Technical Bulletin

Model
911 C2/C4

Subject: Temperature Sensor for
Engine Compartment Blower

Number
9204

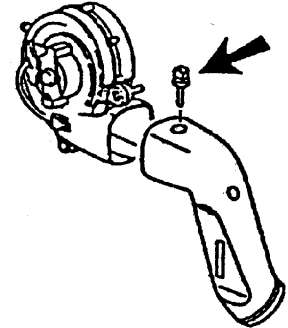
General Information: As of January 1992, the sealing of the sensor contacts and the sensor housing was improved. The sensor with improved sealing is marked as follows:

- Temperature sensor tip has white sealer.
- Electrical connectors are sealed with transparent sealer.
- A green paint dot on sensor housing (temporary).
- Production date stamped in black ink in the area of "Hella" marking.
From production date 421 (42 = week, 1 = 91 year)
indicates new version sensor.

Repair Information: Only the new version temperature sensor is available for repairs. When connecting the cable harness to the sensor, be certain the harness connector sealing gasket is in place.
